UNITED STATES
DEPARTMENT OF THE INTERIOR
BUREAU OF LAND MANAGEMENTFORM APPROVED
OMB NO. 1004-0135
Expires: July 31, 2010**SUNDRY NOTICES AND REPORTS ON WELLS**
Do not use this form for proposals to drill or to re-enter an abandoned well. Use form 3160-3 (APD) for such proposals.**SUBMIT IN TRIPLICATE - Other instructions on reverse side.**

PLUG AND ABANDONMENT PROCEDURE

Jicarilla Apache 102 #3

Re: Permanent Abandonment
Well: 3 Jicarilla Apache 102

Jicarilla Apache 102 #3

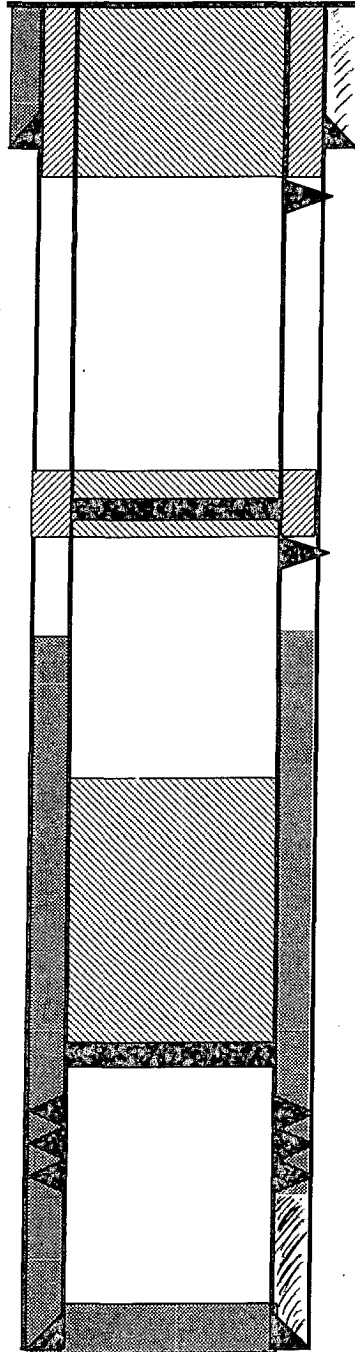
1. Plugging operations authorized are subject to the attached "General Requirements for Permanent Abandonment of Wells on Federal and Indian Lease."
2. Farmington Office is to be notified at least 24 hours before the plugging operations commence (505) 599-8907.
3. The following modifications to your plugging program are to be made:
 - a) Bring the top of the Pictured Cliffs/Fruitland/Kirtland/Ojo Alamo plug to 3198.
 - b) Place the Nacimiento plug from 2008' – 1908' inside and outside the 5 ½" casing.

You are also required to place cement excesses per 4.2 and 4.4 of the attached General Requirements.

2008 1908
Plug #2: 2225' - 2425'
Class B cement, 47 sxs:
17 inside and 30 outside

Ojo Alamo @ 3195' *est
3246

3198
Plug #1: 3755' - 3345'
Class B cement, 58 sxs
